STERLING RANCH FILING NO. 2 - TRACTS AND RIGHT-OF-WAY - DRAINAGE & BRIDGE FEES (2020)

DRAINAGE MAP
 STERLING RANCH FILING 2
 JOB NO. 25188.01
 8/18/21
 SHEET 3 OF 7

DETENTION BASIN STAGE-STORAGE TABLE BUILDER

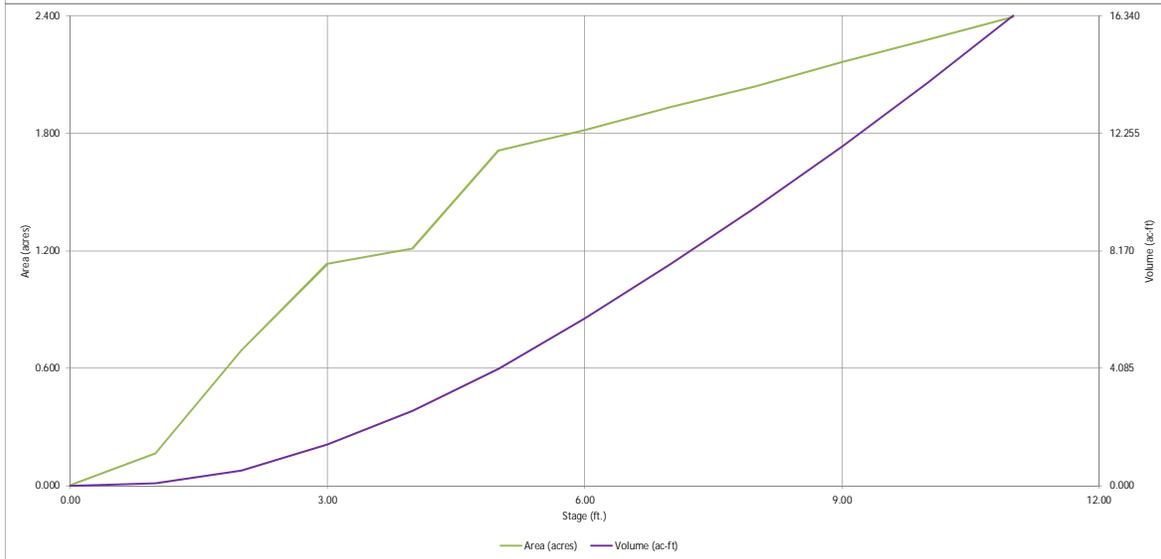
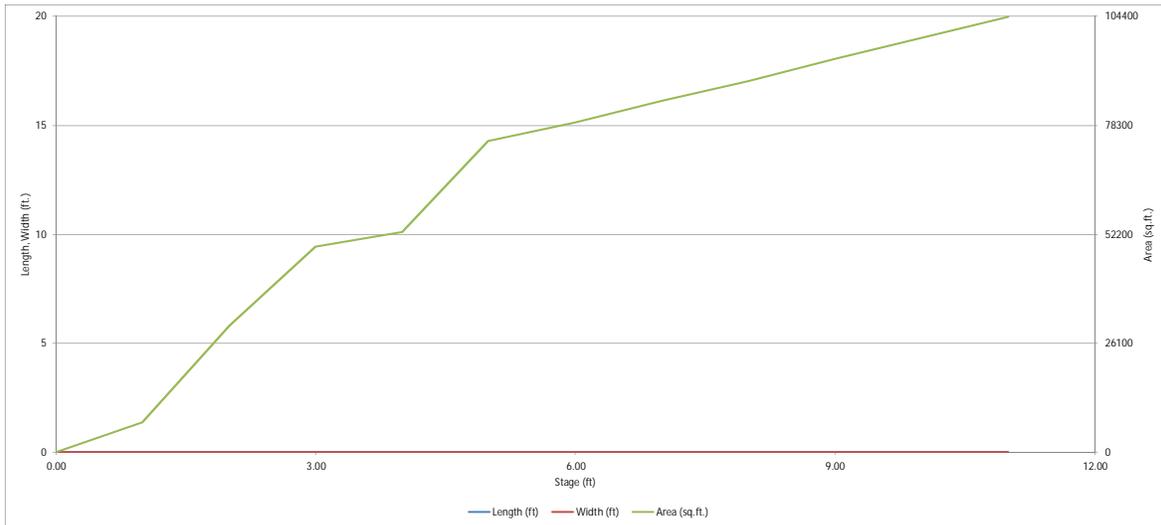
Provide the next
UD-Detention sheets

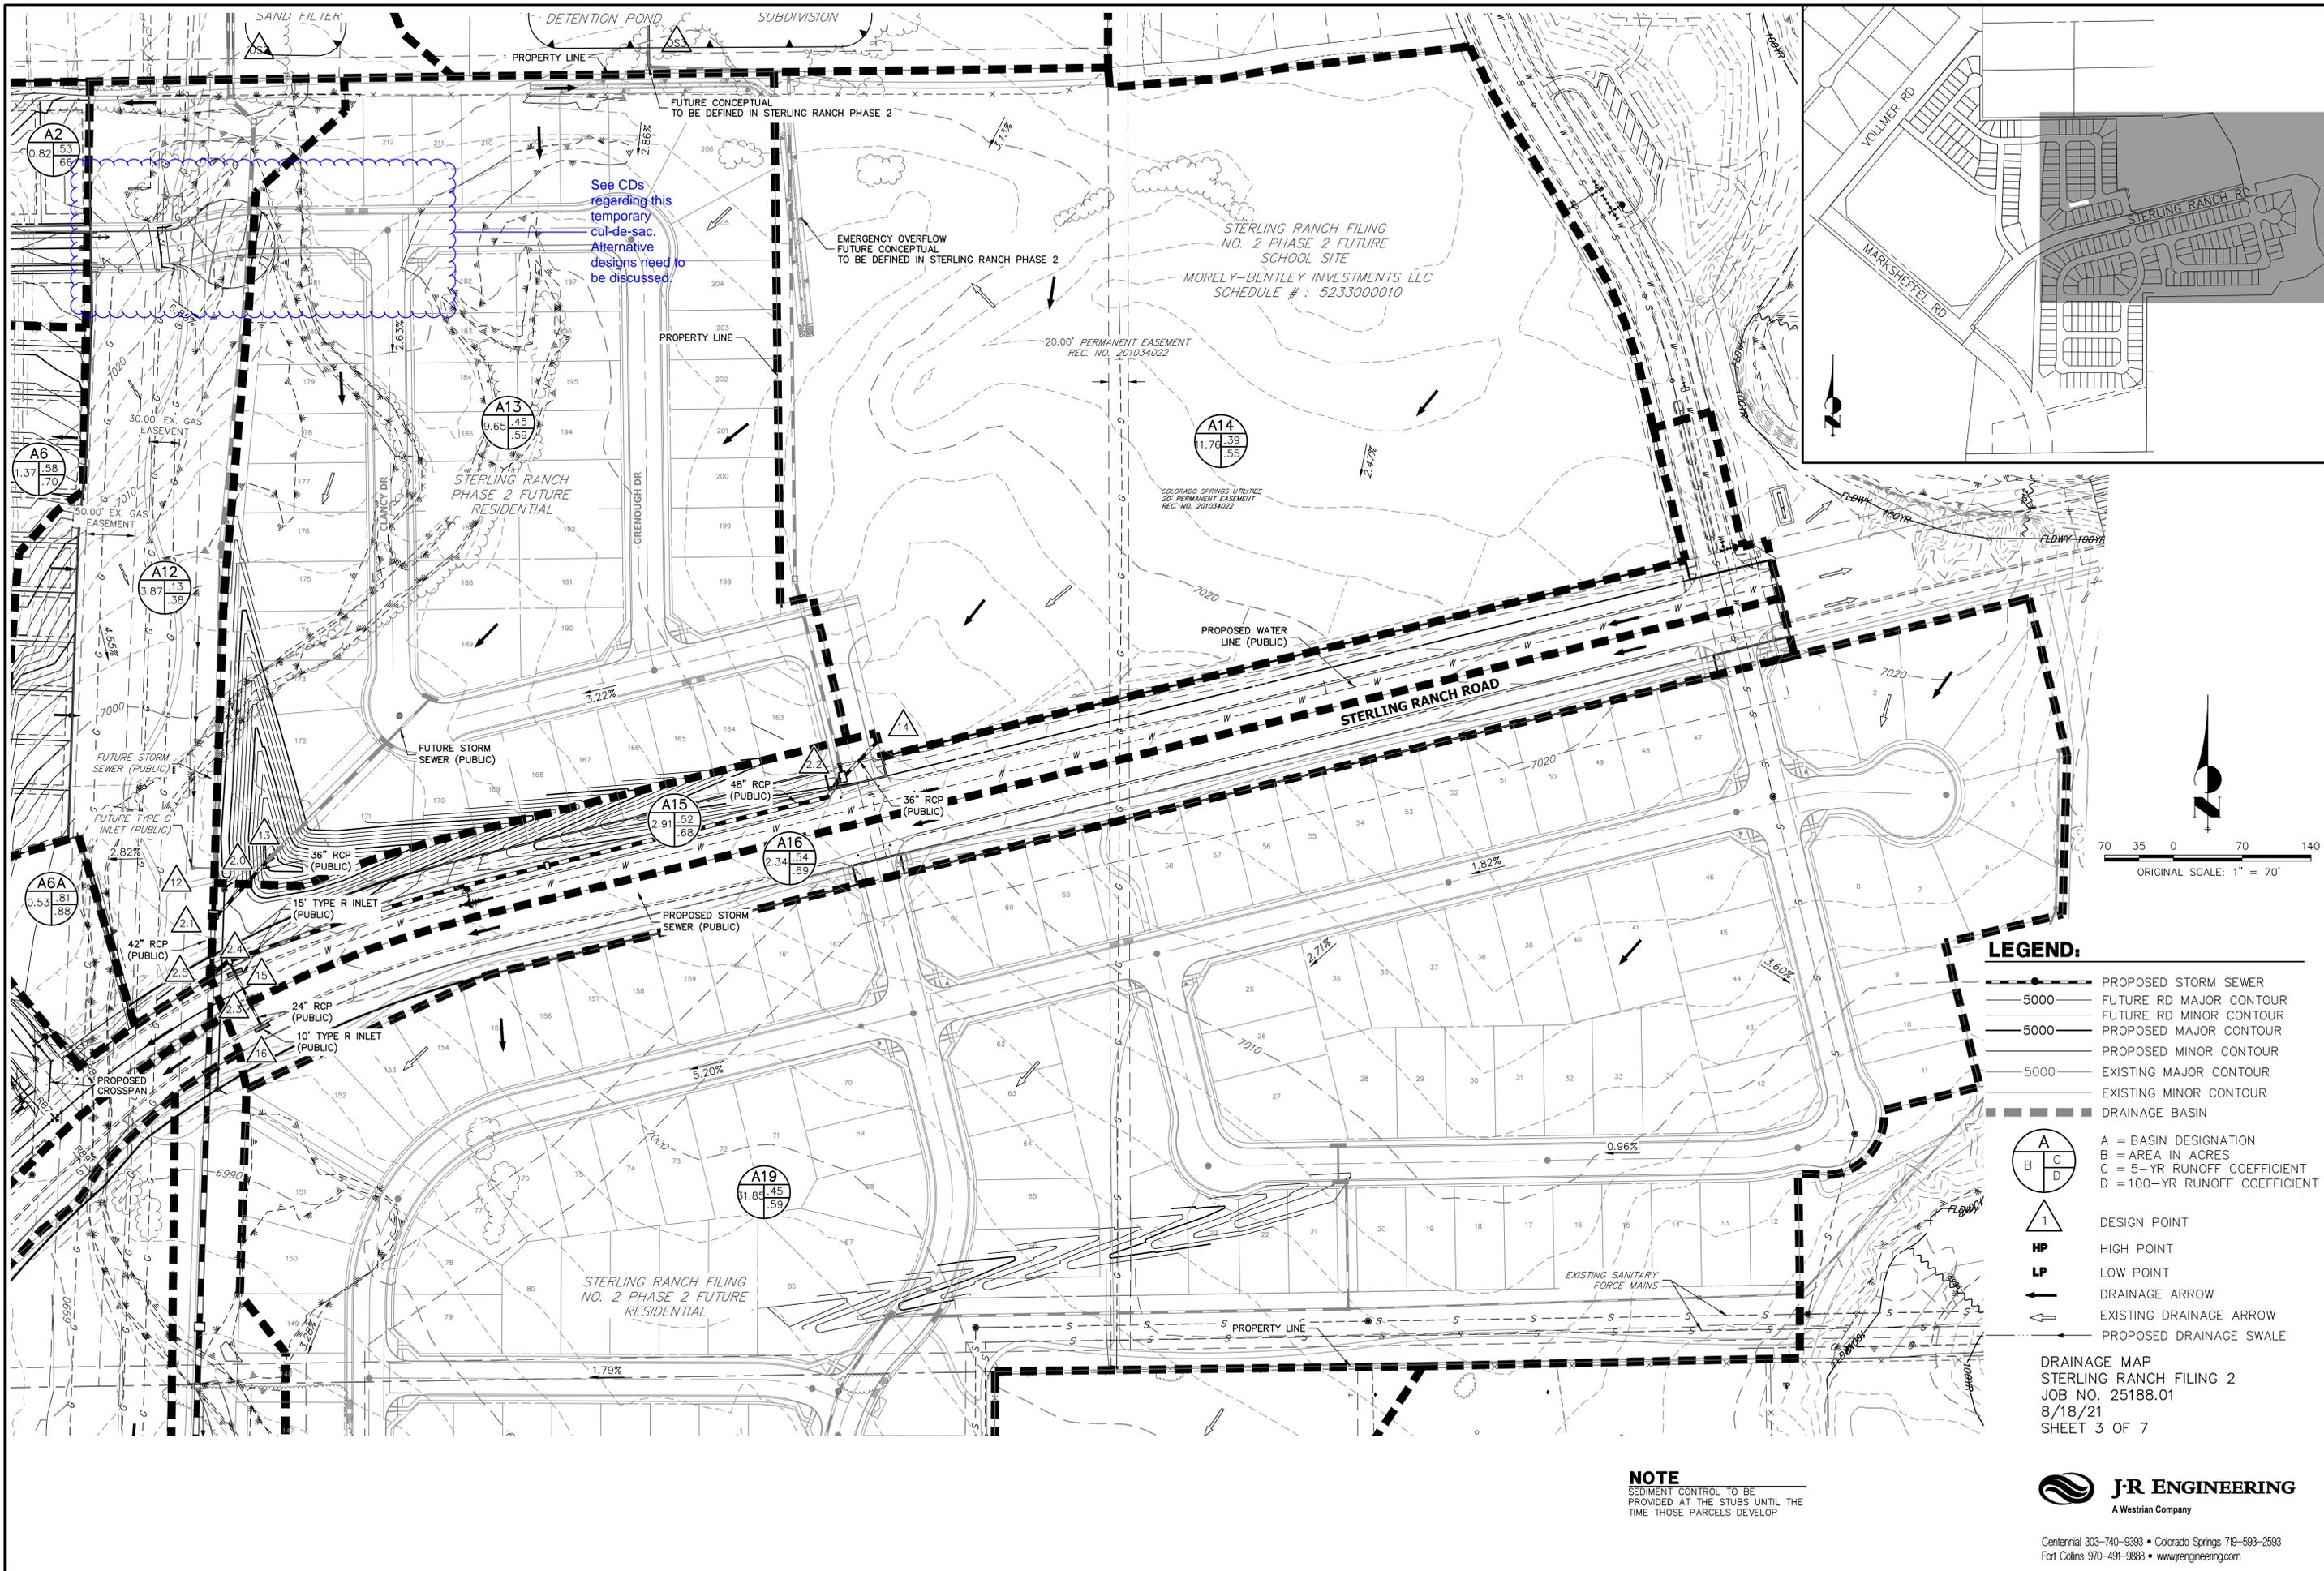
Verify; Staff's interpolation is ~49%

See CDs regarding this temporary cul-de-sac. Alternative designs need to be discussed.
